Your Reference
WAR170229
Our Reference
366441

Featherston Wastewater Treatment Plant Resource Consent Applications - Response to Request for Further Information (s92)

2 June 2017

Figure 1: Dissolved oxygen concentration

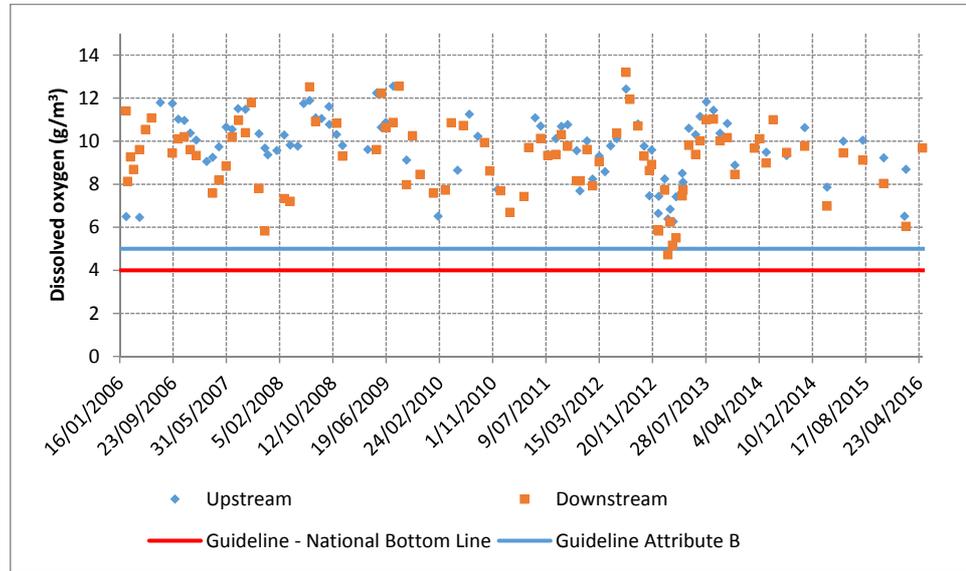
- 3. an assessment against the PNRP DO standards, and also comment on how future compliance with this standard will be assessed; and*

The DO of the discharge was measured routinely downstream in the discharge from 2006 to 2016. During that time there was only one downstream measurement below 5 mg/L, the most stringent guideline from the PNRP, and this measurement was 4.7 mg/L (see Figure 1).

Therefore, given the current discharge is not significant impacting on the DO concentration downstream of the discharge, and the discharge frequency and volume will decrease with the development it is considered likely that the discharge will be fully compliant with the PNRP Policy P71 for DO.

Figure 5.1: Soil Distribution

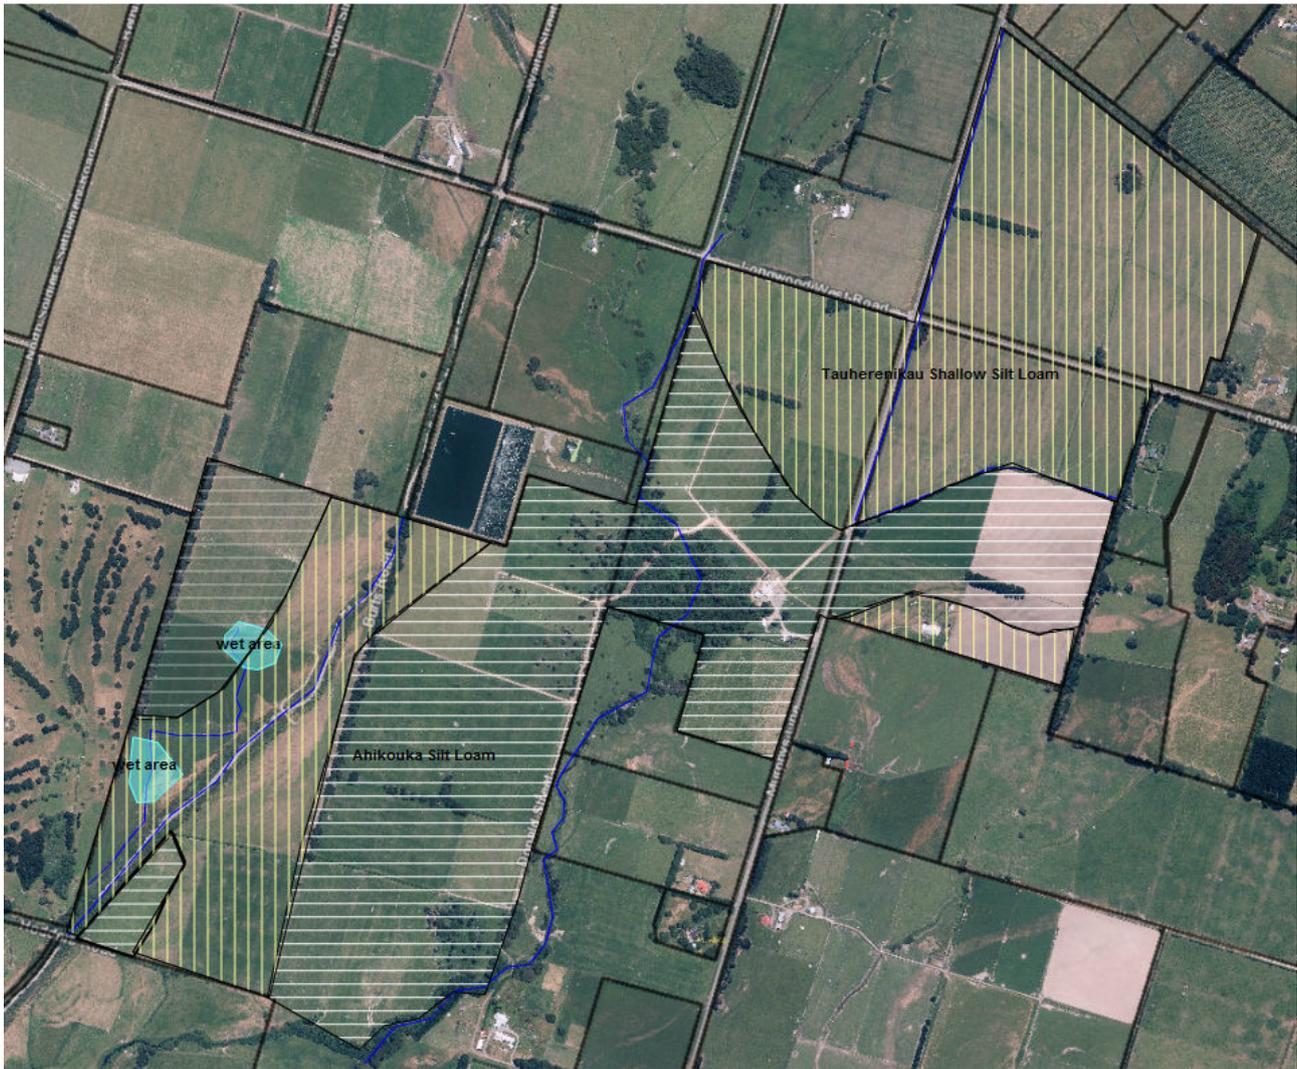
In the section of the AEE where soils are discussed there is reference to site investigations and soil mapping undertaken for Sites A and B by LEI. Can you please provide us with these soil maps and also indicate what scale was the mapping done at? Also what sampling scale of core samples and observations were used and clarify any laboratory test or observations that were conducted at the time to help confirm mapping and the soil classification.

Contained within these reports is detailed descriptions of the investigations undertaken. A soil distribution map is provided as Figure 5.1 of the Site B investigation report based on a site walk-over including profiles and holes.

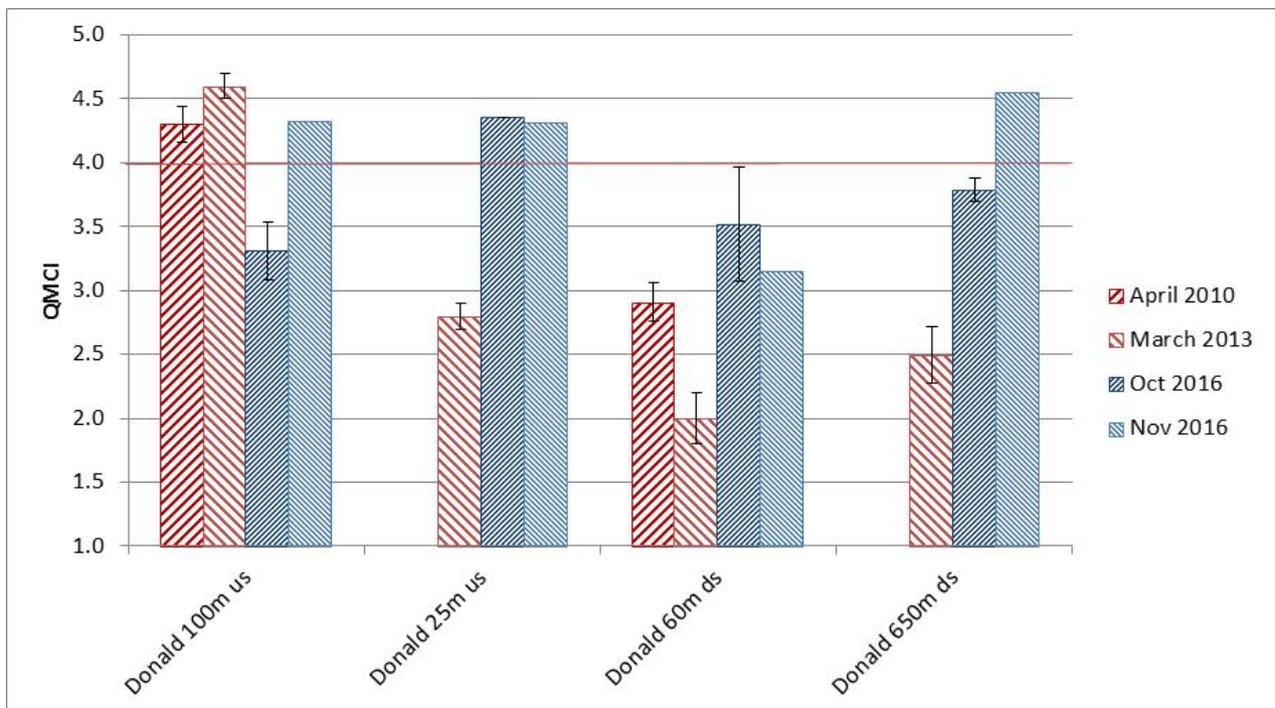
- 1. assessment of existing ecological data against the 20% QMCI change (PNRP Policy P71). Is this standard currently met downstream of the zone of reasonable mixing? Will it be met under the various phases of the proposal (accepting this will have to be based on expert opinion)? As it is, the ecological assessment report (Appendix 11b) makes reference to significant changes etc, but no specific reference to this standard. Given this standard is in the PNRP, we feel an assessment should be provided and it would be useful to compare all existing data (Coffey, Forbes and River Lakes) to the standard;*

In October 2016 the average QMCI was 3.8 and 3.7 for the two upstream sites and two downstream sites respectively – 3% lower downstream. There was no significant difference in the QMCI scores between the combined upstream and downstream sites. The lowest QMCI score was at the 100m upstream site (Figure 1).

In November 2016 the average QMCI was 4.3 and 3.9 for the two upstream sites and two downstream sites respectively – 9% lower downstream. There was not a consistent upstream downstream difference in QMCI scores. The site 60m downstream had a QMCI score of 3.2, which was 25% lower the upstream sites; and the site 650m downstream had a QMCI score of 4.5, which was 5% higher than the upstream sites. Despite a decline in QMCI at the 60m downstream site, the abundance of sensitive mayfly taxa was similar to the most upstream site (see also discussion in Hamill 2017).
